## Model Series 463 AMG: Active Distance Assist and Active Brake Assist IC Message and DTC U0416FE

Topic number	LI54.71-P-078112
Version	3
Function group	54.71 - Camera and radar-assisted assistance systems
Date	6/17/25
Validity	463 AMG
Reason for change	Updating remedy

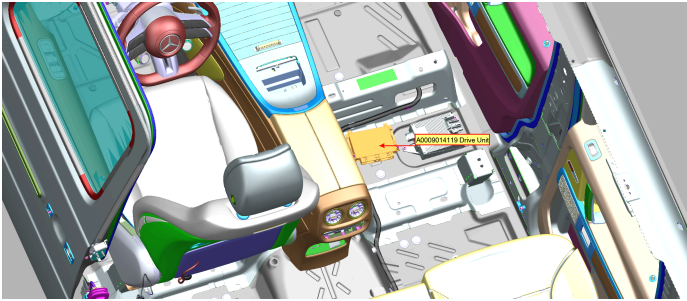
Missing wire between Drive Unit (N145) and Supercap (C8).

- Using a red/white cable with cross-section 0.35 mm<sup>2</sup> and overall length of approximately 2m.
- Connect Drive Unit (N145) plug A pin 18 to the 3-pin plug of the Supercap (C8) terminal 15 pin 2. Reference the new wire routing location as shown by the red line in "Picture 1 - Connection from Supercap to Drive Unit".
- The new wire should be added to the existing wiring harness as shown by the red line "Picture 1 - Connection from Supercap to Drive Unit".
- Z-Splice is the preferred method using A 000 982 91 10.
- Crimp Contact Pin (MLK) for the Drive Unit (N145) is A0485450328.
